UNITED STATES PATENT AND TRADEMARK OFFICE

APPLICATION NO.	FILING DATE	FIRST NAMED INVENTOR	ATTORNEY DOCKET NO.	CONFIRMATION NO.
09/271,691	03/18/1999	CRAIG M. CONWAY	5150-30300	4606

**Office Action Summary**

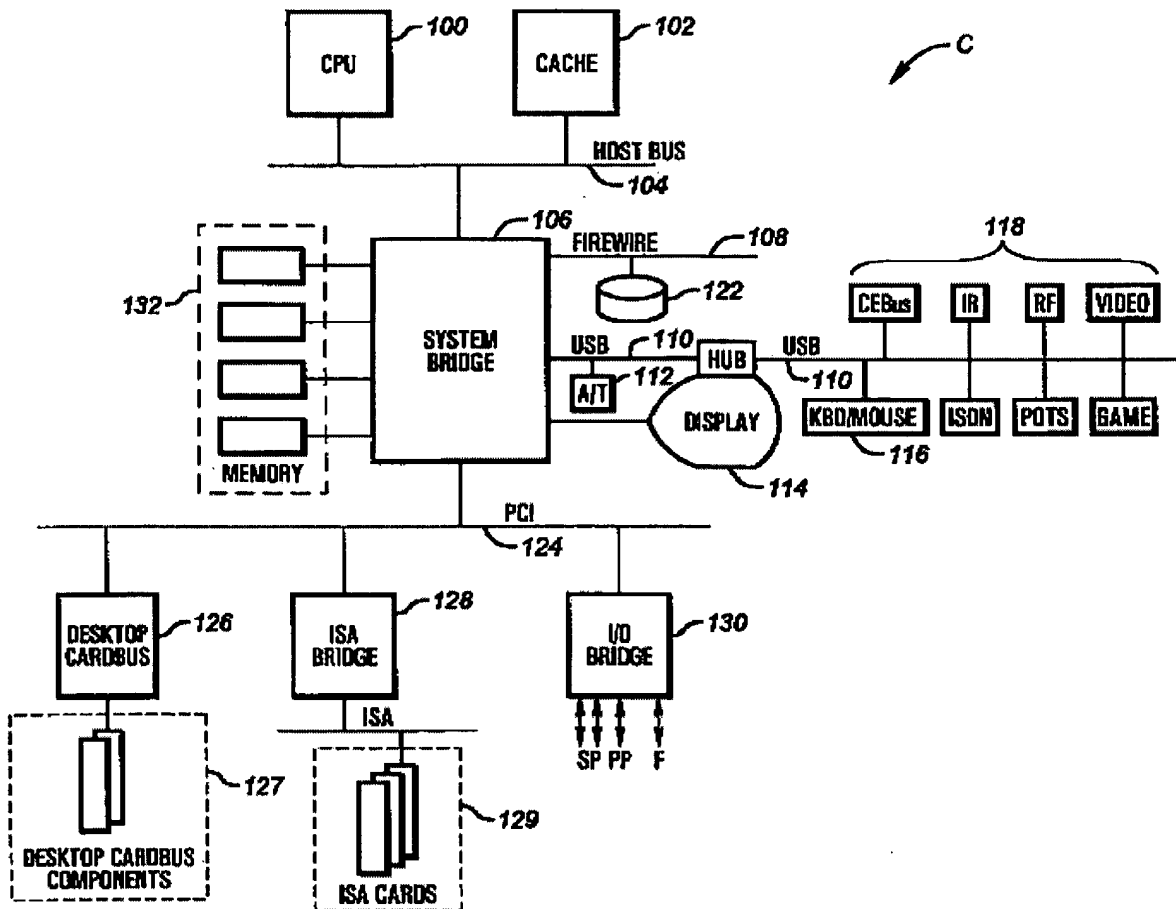
Baker teaches various buffers (Fig. 7, or 10 and cols. 17, line 46-col. 20; col. 29-36) such as FIFOs (e.g., 716, Fig. 7; col. 7, lines 6-11; 764; col. 29, lines 20-63), pipeline control logic (Fig. 7 and respective disclosure; Fig. 8; col. 20, line 64-col. 22, line 6), and that it is well known to predetermine or predict the size of the data bursts that are about to be transmitted (cols. 13-16, especially Table 1), and therefore, Baker does teach the claimed limitations such as a first phase (address or request phase) which uses predetermined byte enable values (Table 1).

It would have been obvious to use the well known byte enable sizes so that the data can be sent more quickly.

**FIG. 1**

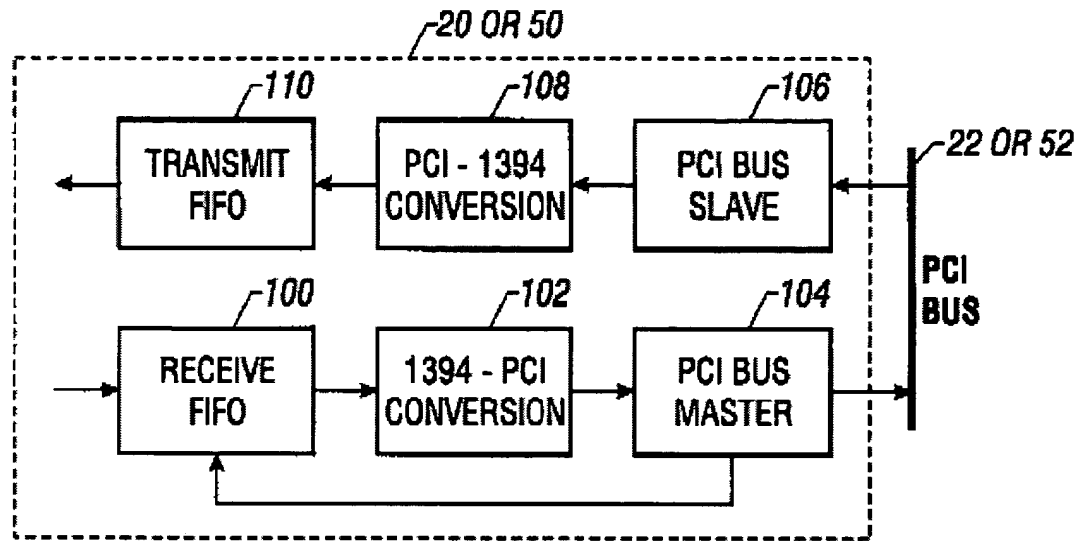
As shown in e.g., Fig. 1, Welker discloses the parallel/PCI to serial/1394 conversions.
